ADDENDUM No. 1

RFP No. 26-17

S Maple, Arbordale St, Sherwood St, and Sherwood Cir Improvements

CITY OF ANN ARBOR - ENGINEERING
PUBLIC SERVICES - DISTRICT IMPROVEMENTS
TYPICAL SECTIONS
EX AND PROP SECTIONS

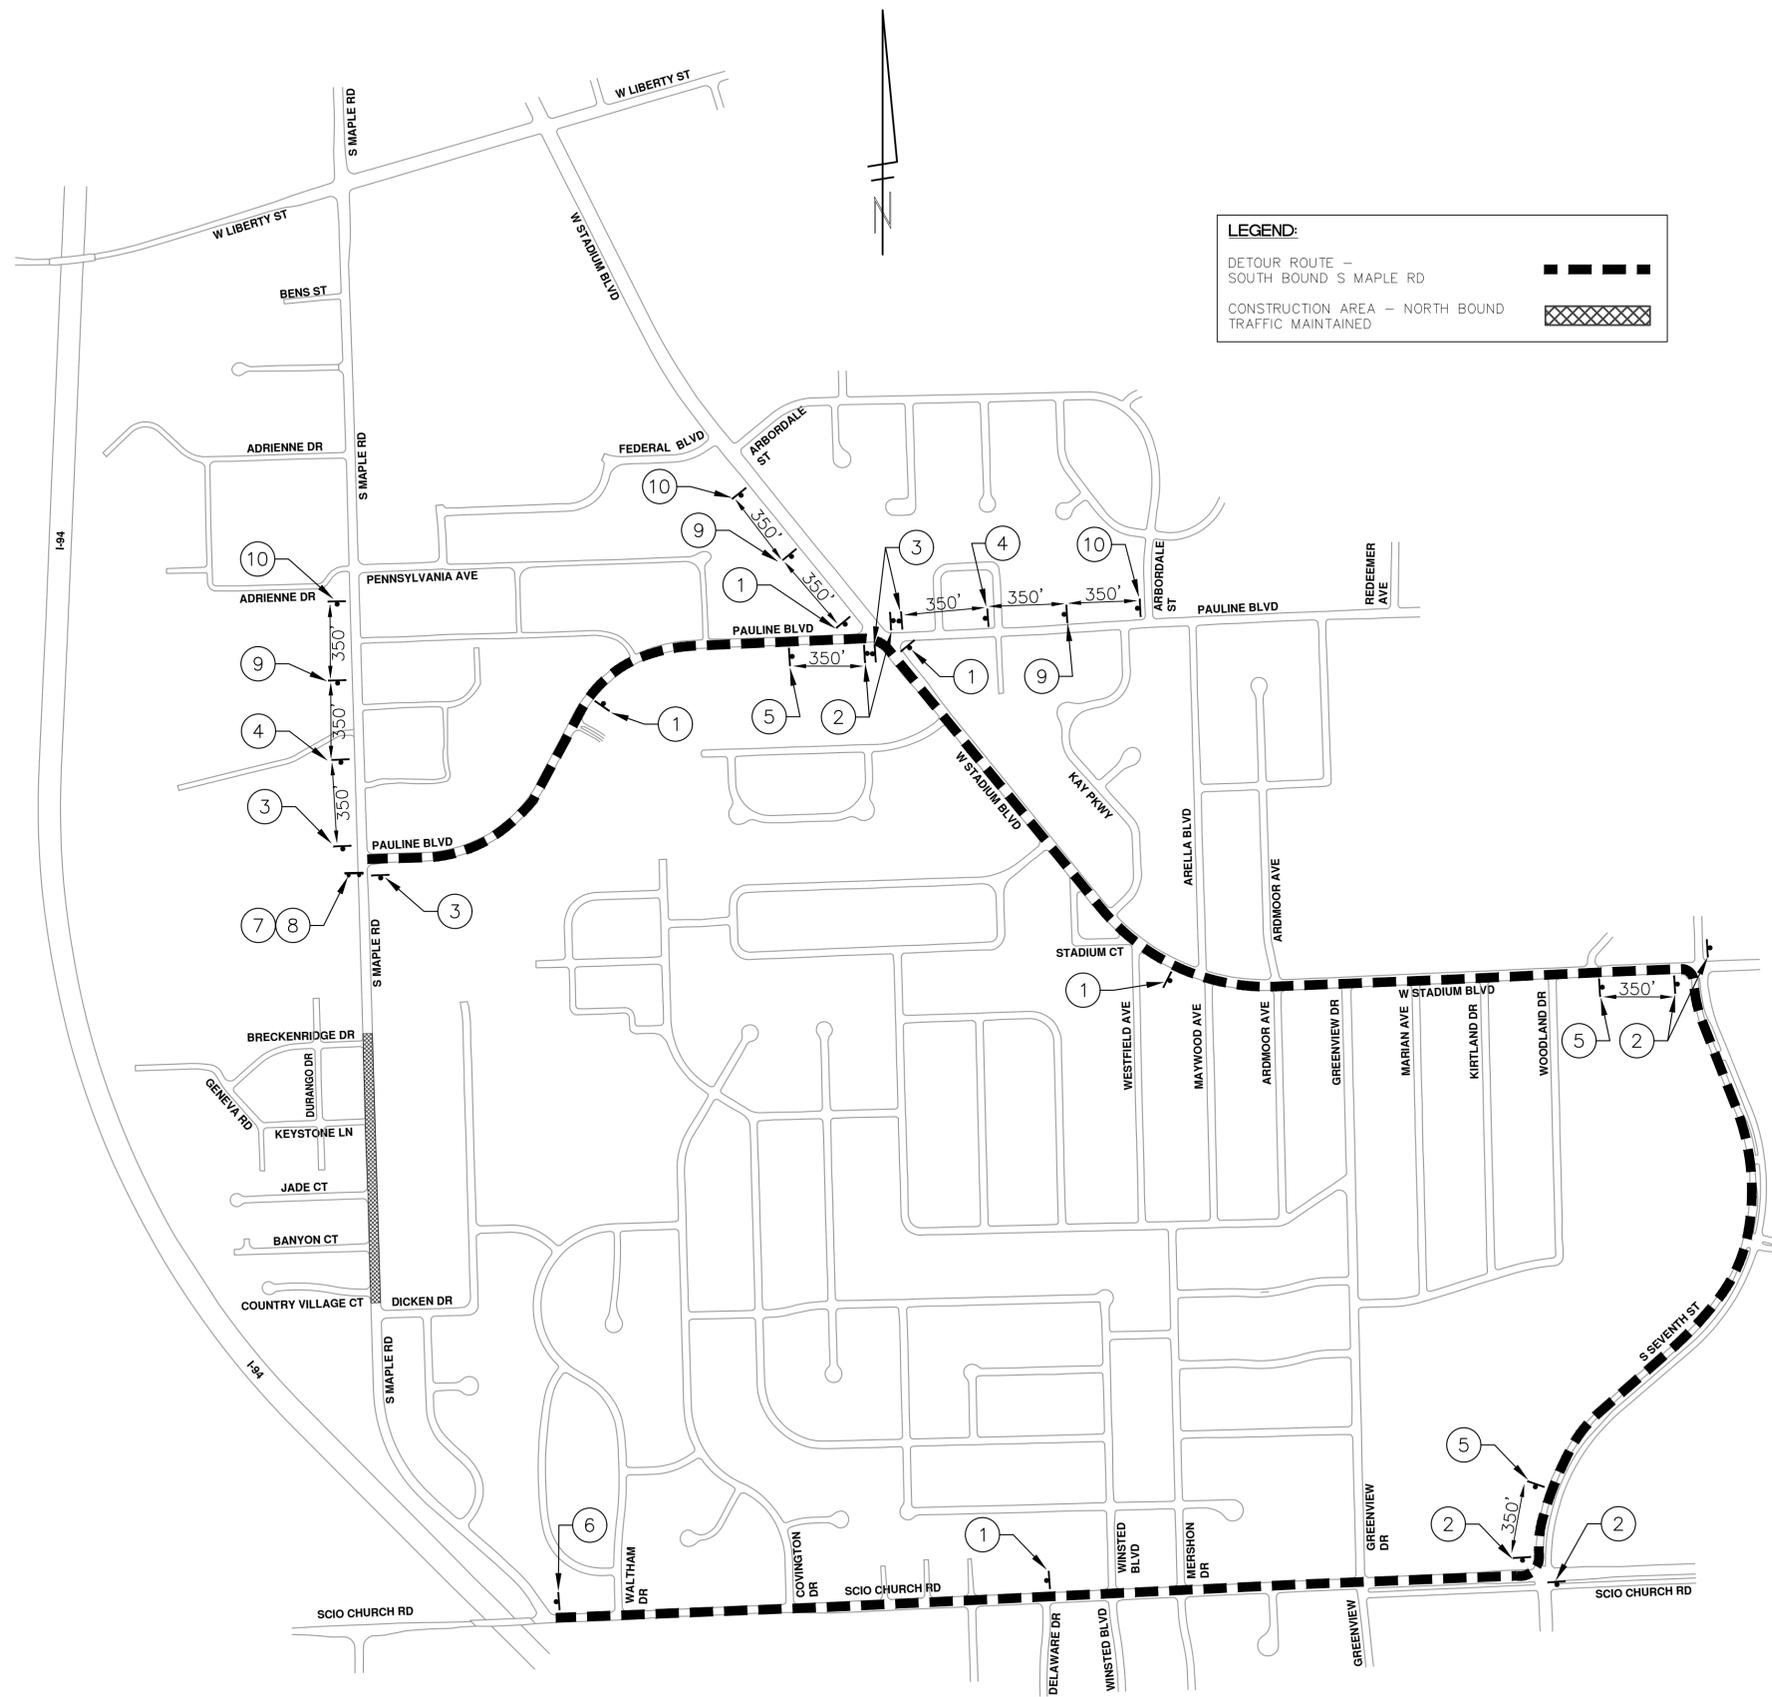
Plan sheets replaced in their entirety.
Area 1 Maple; 1-23
Area 2 Arbordale Sherwood 1-53
Changes include: Revised cross sections. Extent of work is unchanged.

CITY OF ANN ARBOR
ENGINEERING
ARBORDALE SHERWOOD WATER MAIN
WATER MAIN PLAN & PROFILE - ARBORDALE ST
WATER 17+50 TO 21+00

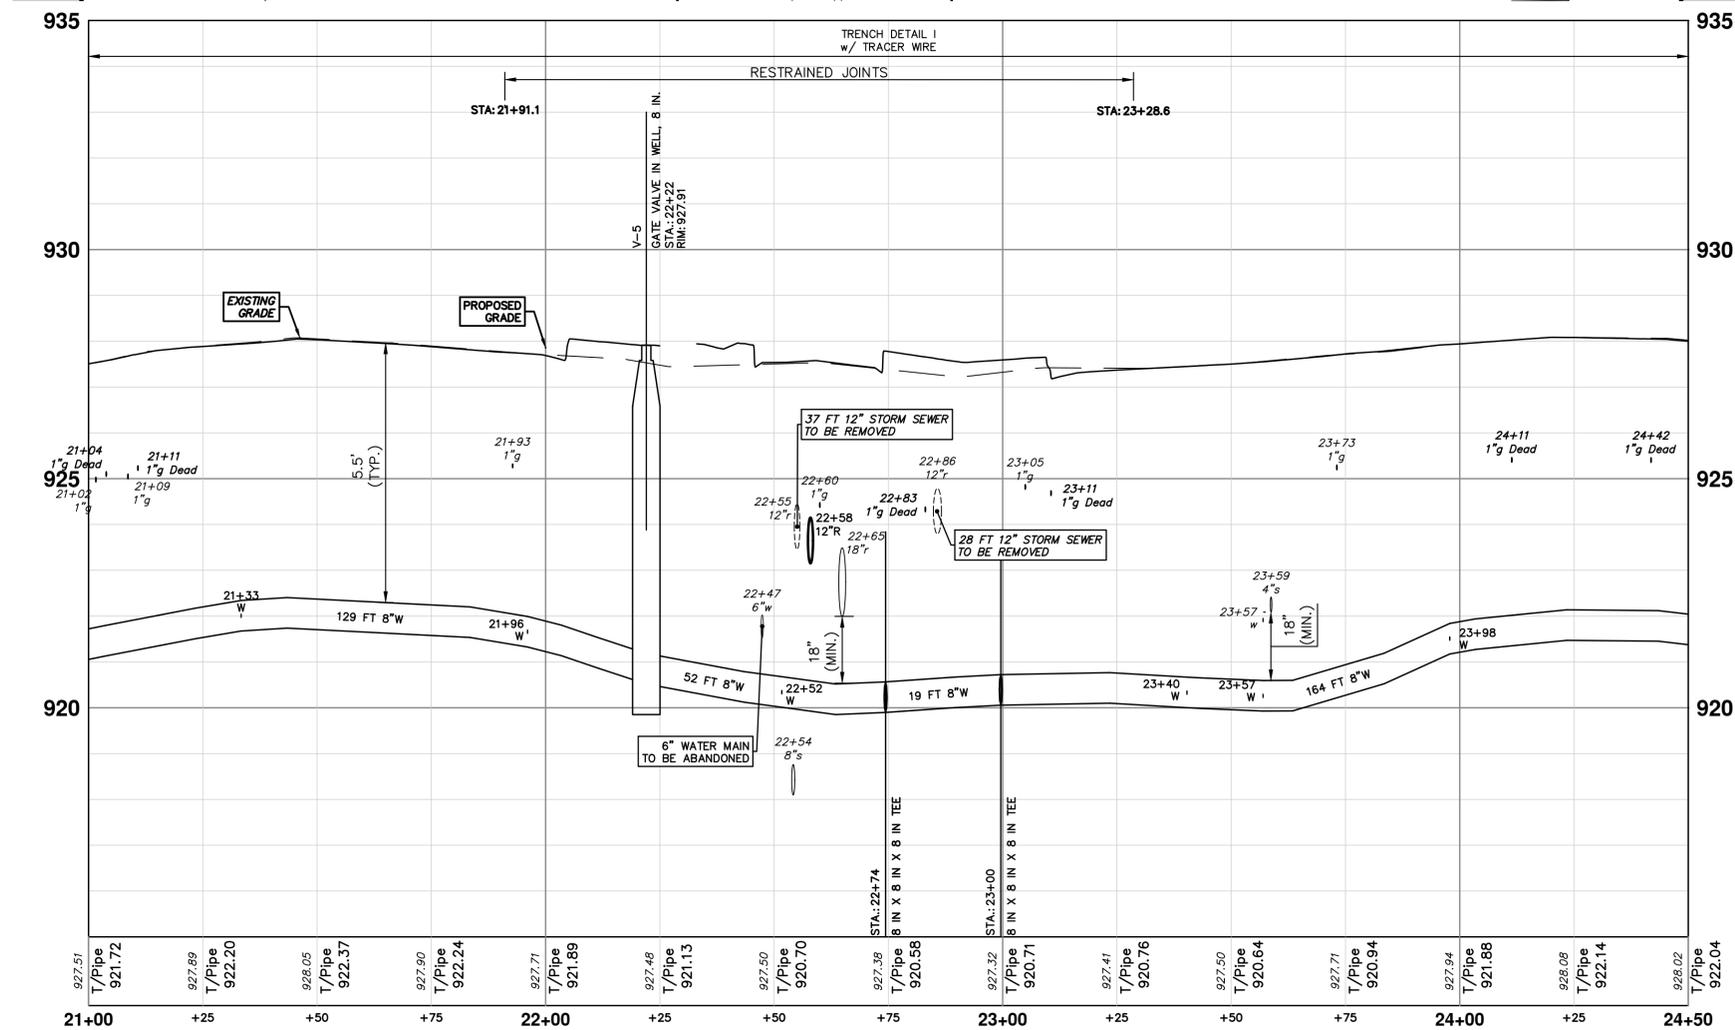
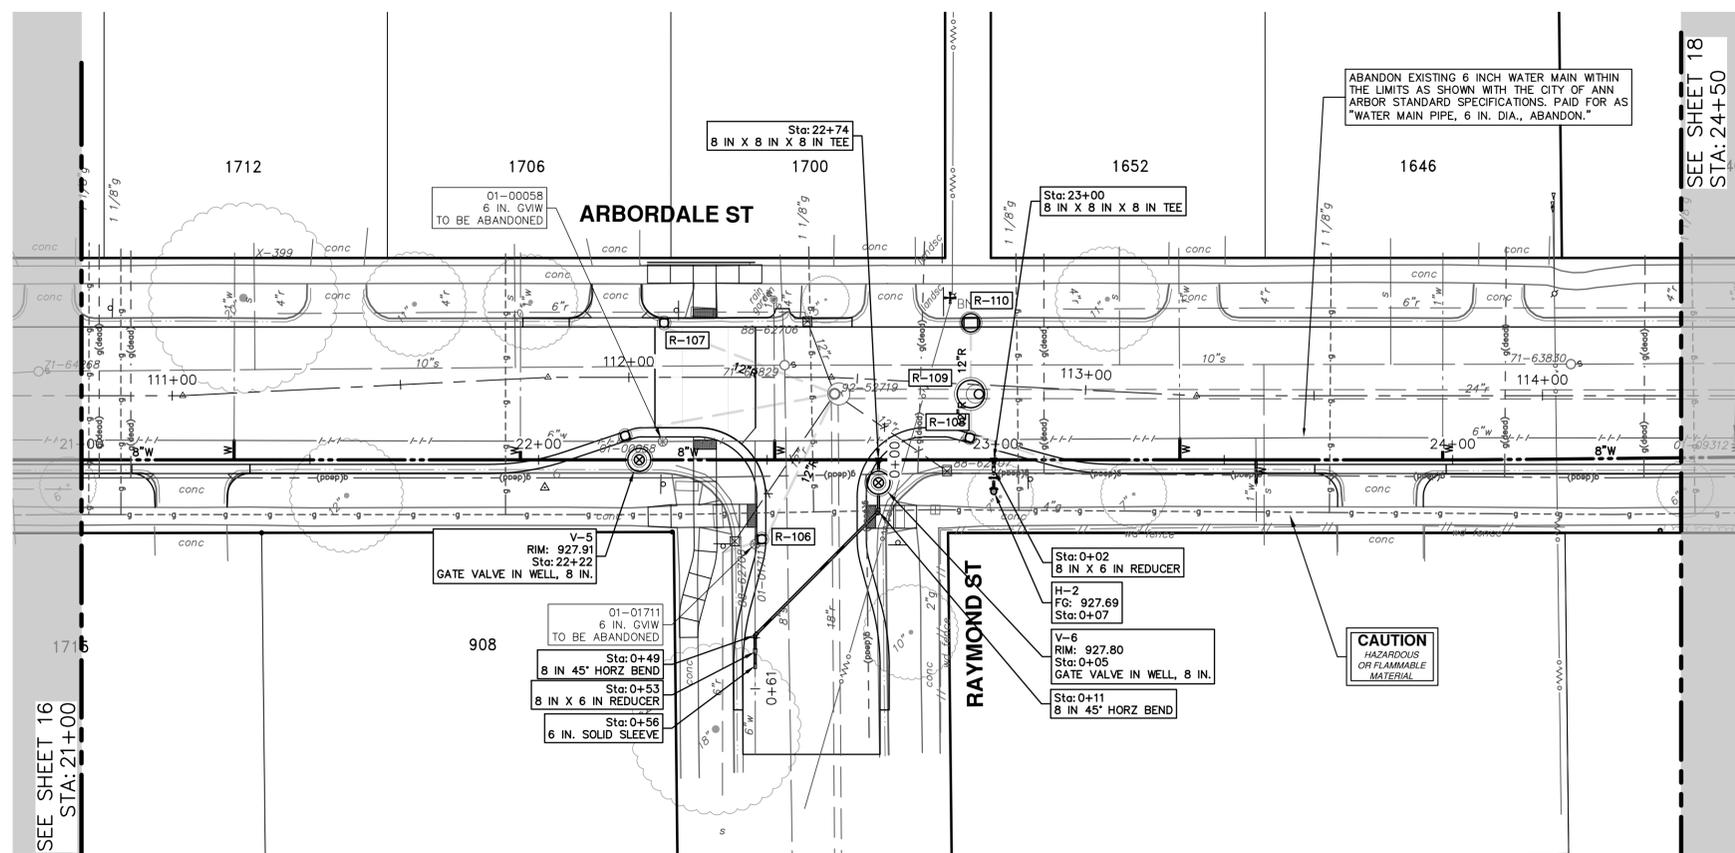
Question 40: In Area 1 at the Breckenridge Connection there will a piece of 10" pipe required to go from the 12"x10" Reducer to the 10" Sleeve. (Plan Sheet 16) I do not see a 10" water main pipe item. Can you please add to Area 1 bid Form?

Answer 40: Yes See updated Schedule of Pricing / Cost
